APPLICATION NO.	FILING DATE	FIRST NAMED INVENTOR	ATTORNEY DOCKET NO.	CONFIRMATION NO.
09/848,819	05/03/2001	Richard T. Allen	ACS 57527	8480

Office Action Summary

DETAILED ACTION

FIG. 10

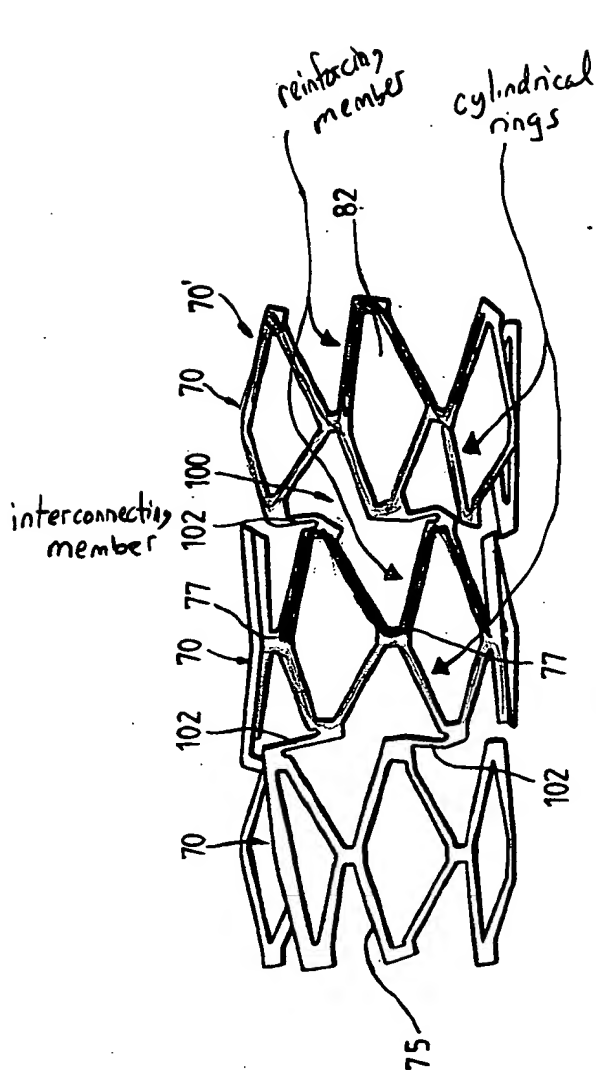
10. Claims 1,2,4,6,10,11,15,16,18,19, and 21 are rejected under 35 U.S.C. 102(b) as being anticipated by Palmaz US PN 5,102,417.

See the attached sheet specifically showing location of the cylindrical rings, reinforcing members, and interconnecting members in figure 10. Also see lines 3-18 of column 7 and the abstract. Regarding claim 4, the interconnecting member connects a reinforcing member of a valley to a valley of an adjacent cylindrical ring.
